SUBJECT: ISSUANCE OF AMENDMENT NO. 52 TO FACILITY OPERATING LICENSE
NO. NPF-41, AMENDMENT NO. 38 TO FACILITY OPERATING LICENSE
NO. NPF-51 AND AMENDMENT NO. 24 TO FACILITY OPERATING
LICENSE NO. NPF-74 FOR THE PALO VERDE NUCLEAR GENERATING
STATION, UNITS 1, 2, AND 3 (TAC NOS. 71527, 71528 and 71529)

The Amendments revise those portions of the Technical Specifications regarding the Reactor Vessel Pressure-Temperature (P-T) curves and Low Temperature Overpressure Protection (LTOP) enable temperatures, in accordance with the irradiation damage prediction methodology of Revision 2 of Regulatory Guide 1.99, "Radiation Embrittlement of Reactor Vessel Materials."

PALO VERDE NUCLEAR GENERATING STATION, UNIT NO. 1

Amendment No. 52
License No. NPF-41

FIGURE 3.4-2a
 REACTOR COOLANT SYSTEM PRESSURE/TEMPERATURE
 LIMITATIONS FOR LESS THAN 8 EFFECTIVE
 FULL POWER YEARS OF OPERATION

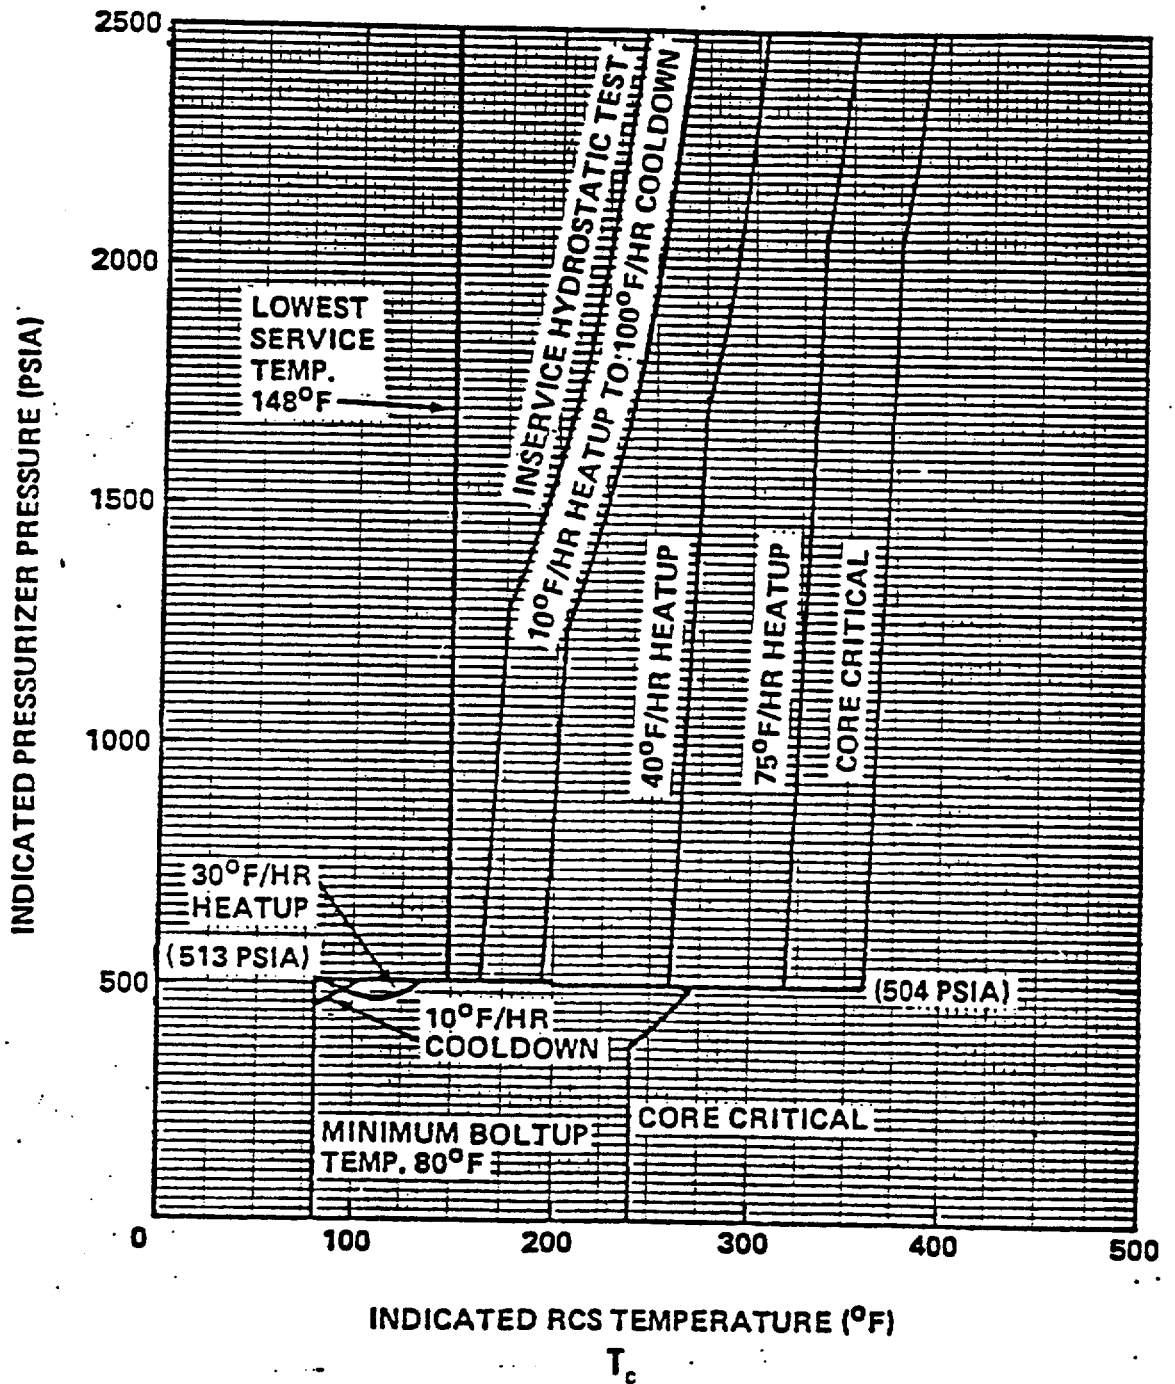
3.4.8.1 The Reactor Coolant System (except the pressurizer) temperature and pressure shall be limited in accordance with the limit lines shown on Figures 3.4-2a or 3.4-2b during heatup, cooldown, criticality, and inservice leak and hydrostatic testing with:

The pressure-temperature limit lines shown on Figures 3.4-2a and 3.4-2b for criticality and for inservice leak and hydrostatic testing have been provided to assure compliance with the minimum temperature requirements of Appendix G to 10 CFR Part 50. The reactor vessel material irradiation surveillance specimens are removed and examined to determine changes in material properties. The results of these examinations shall be used to update Figures 3.4-2a and 3.4-2b based on the greater of the following:

FIGURE 3.4-2a
REACTOR COOLANT SYSTEM PRESSURE/TEMPERATURE
LIMITATIONS FOR LESS THAN 8 EFFECTIVE
FULL POWER YEARS OF OPERATION

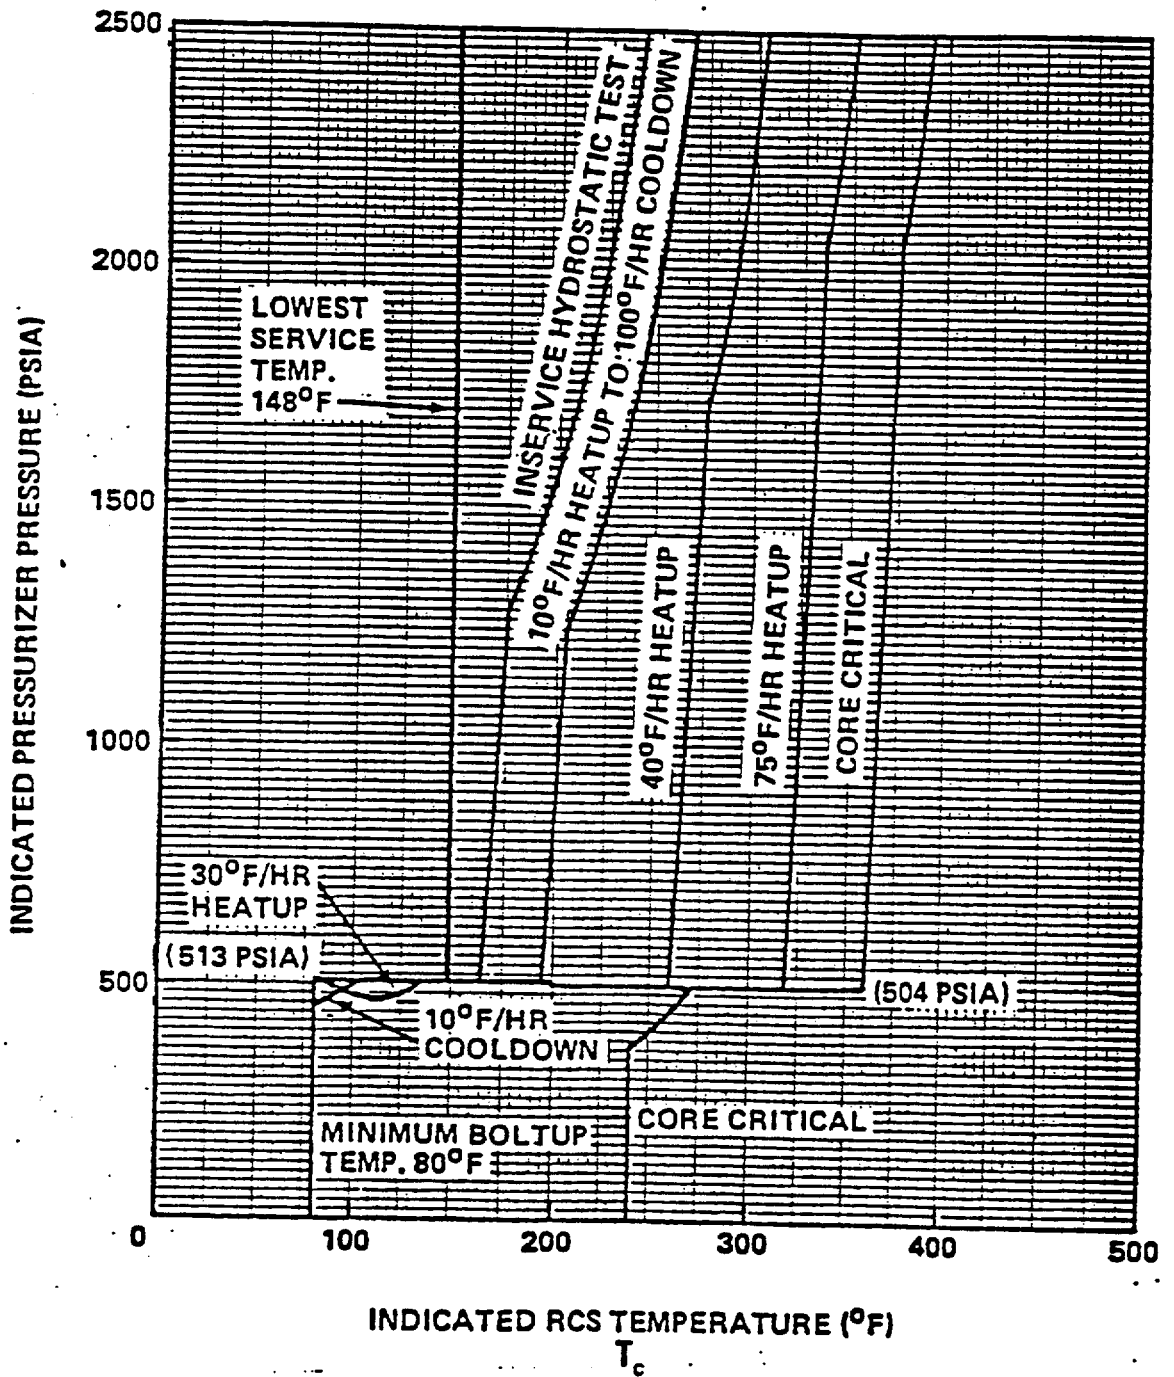
APS provided its updated pressure-temperature curves in proposed Technical Specification Figure 3.4-2a (for less than 8 EFPY) and Figure 3.4-2b (for 8 to 32 EFPY), changes in the values of the RCS cold leg temperature at which LTOP should be enabled, and the justification for the changes. New heatup and cooldown rates as a function of indicated reactor coolant temperature are also proposed in an updated Table 3.4-3.
